ADA Curb Ramp New Construction Inspection Form (Parallel)

NW Timeric

23885.56

NW Lenux

PARALLEL RAMP (PL)

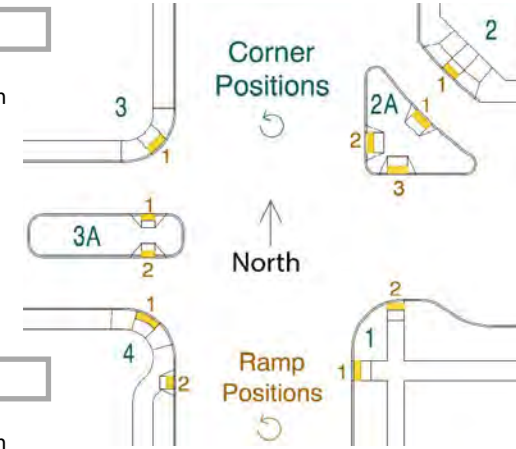
☐ **11.5** $\leq 8.3\%$ ☐ $> 8.3\%$ ☒

11.3 $\leq |5.0\%|$ ☐ $> |5.0\%|$ ☒

7.3 $\leq 2.0\%$ ☐ $> 2.0\%$ ☒

7.1 $\leq 2.0\%$ ☐ $> 2.0\%$ ☒

3.5 $\geq 4.0'$ ☐ $< 4.0'$ ☒

NTD Fails RR 1 and Turn space
